From: BRYAN Martin (EXTERNAL AREVA) [Martin.Bryan.ext@areva.com]
Sent: Wednesday, November 03, 2010 4:36 PM
To: Tesfaye, Getachew
Cc: DELANO Karen (AREVA); ROMINE Judy (AREVA); BENNETT Kathy (AREVA); GUCWA Len (EXTERNAL AREVA)
Subject: Response to U.S. EPR Design Certification Application RAI No. 410, FSAR Ch. 6, Supplement 1
Attachments: RAI 410 Supplement 1 Response US EPR DC.pdf

**Request for Additional Information No. 410(4719, 4720), Revision 1
Supplement 1**

U. S. EPR Standard Design Certification

SRP Section: 06.02.04 - Containment Isolation System

Figure 6.2.5-9—Concentration of Hydrogen in the Containment

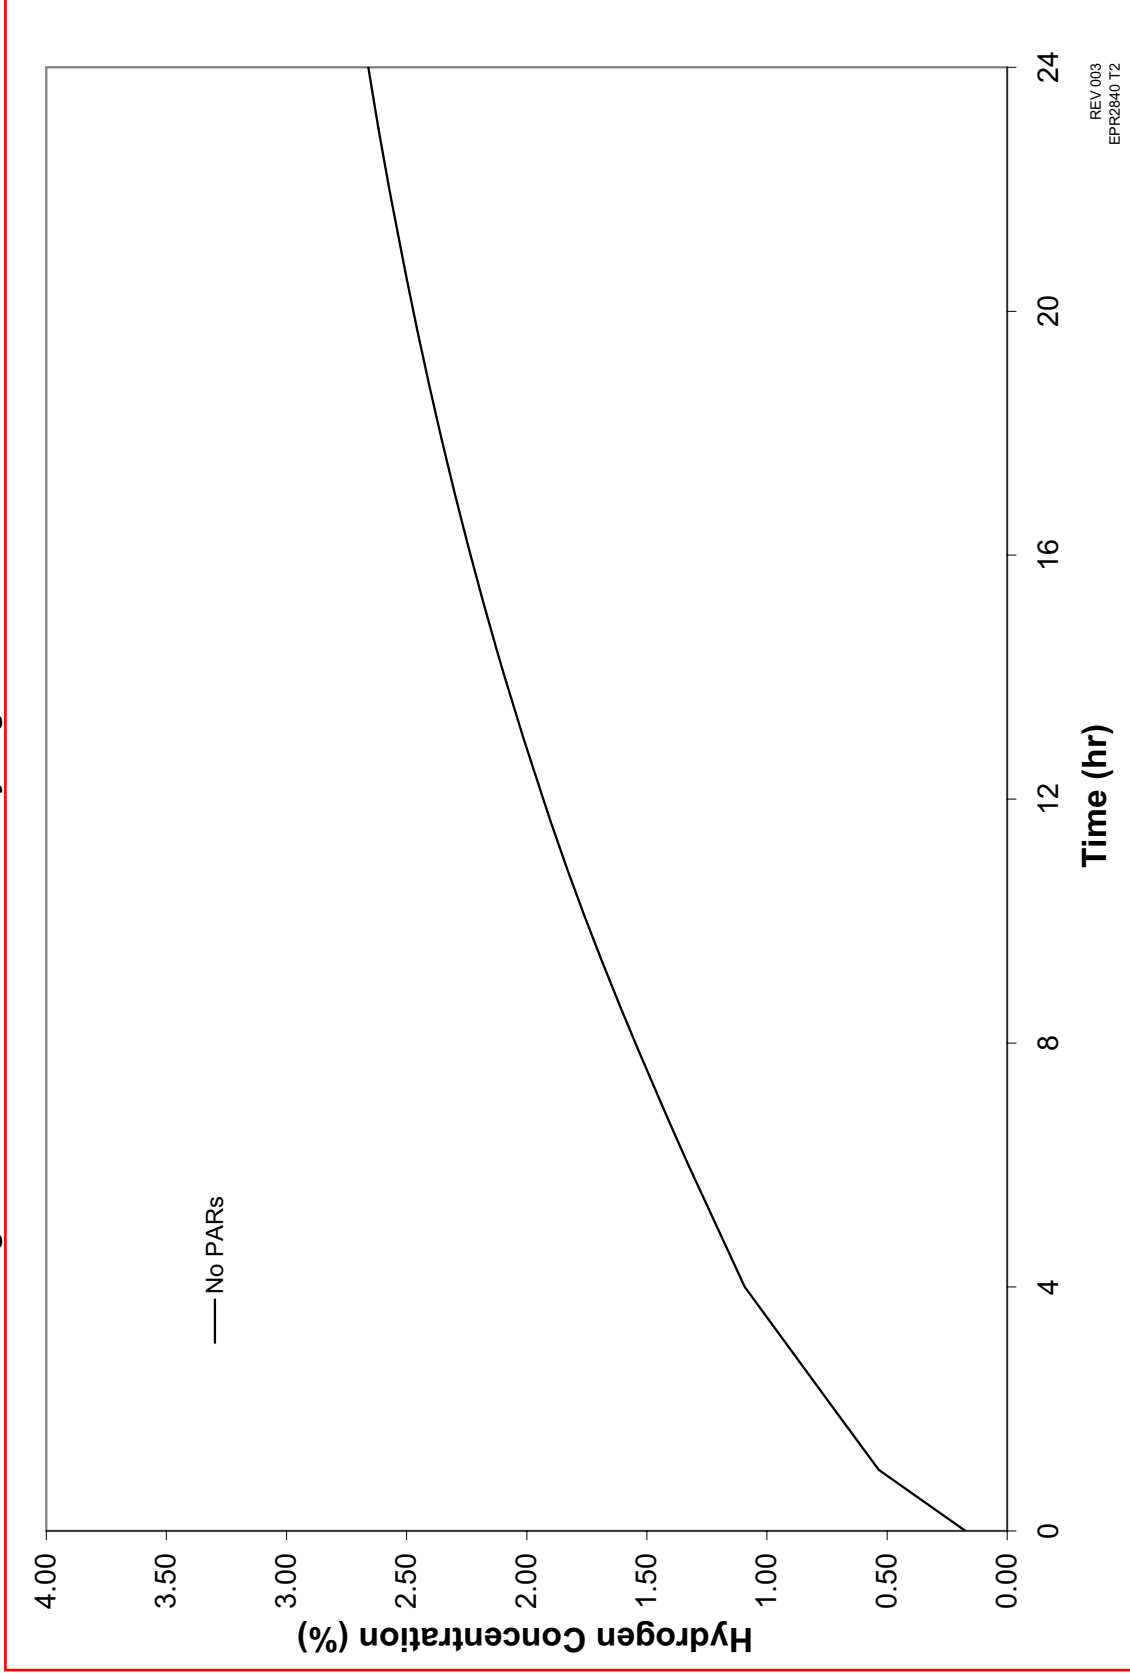
In response to RAI 323, Question 06.02.05-8 (Supplement 1), AREVA noted that the KALI H2 tests examined PAR performance for a broad range of conditions consistent with those anticipated following a design-basis loss-of-coolant-accident, but did not address PAR performance impacts from fission product poisons.

The PAR performance database credited by AREVA NP for the U.S. EPR design is derived from several tests listed in the response. AREVA considers the Integrated Core-Melt-Simulation-Test (1996) program in the aerosol tests of the IPSN/EDF H2 PAR-Test program in Cadarache to be the most important test program concerning poisoning, deposition on and contamination of catalyst in a PAR in the post accident atmosphere. During this program, an AREVA NP designed PAR was subjected to a realistic aerosol exposure generated by a molten core, including poisons such as iodide, tellurium, cesium and antimony.

Provide the following test report(s) AREVA used in concluding that PAR performance would meet the US EPR design criteria for functional performance when exposed to aerosols generated by a molten core, including fission product poisons for significant beyond design basis accidents:

The requested test results are not provided because that information is vendor-specific. AREVA has not committed to a specific vendor for the PARs. To satisfy the NRC concerns about the PARs, U.S. EPR FSAR Tier 2, Section 6.2.5 will be revised to include the performance criteria of the intended functions of components under severe accident conditions in the design specification for component requirements. U.S. EPR FSAR Tier 2, Figure 6.2.5-9 will be revised to show containment hydrogen concentration over the first 24 hours of the event. Because this is the design basis analysis, no credit is taken for the PARs.

U.S. EPR FSAR, Tier 2, Section 6.2.5 and Figure 6.2.5-9 will be revised as described in the response and indicated on the enclosed markup.

Figure 6.2.5-9—Concentration of Hydrogen in the Containment shows the total hydrogen concentration within containment from all sources. The hydrogen remains below the threshold concentration necessary for combustion (4 percent) taking into account no hydrogen recombination from the 47 PARs. ~~Figure 6.2.5-9 also shows the hydrogen concentration within containment for various levels of PAR operation. When all PARs are functioning, the hydrogen concentration remains below a level of 1.5 percent, therefore, hydrogen concentration does not threaten containment integrity.~~
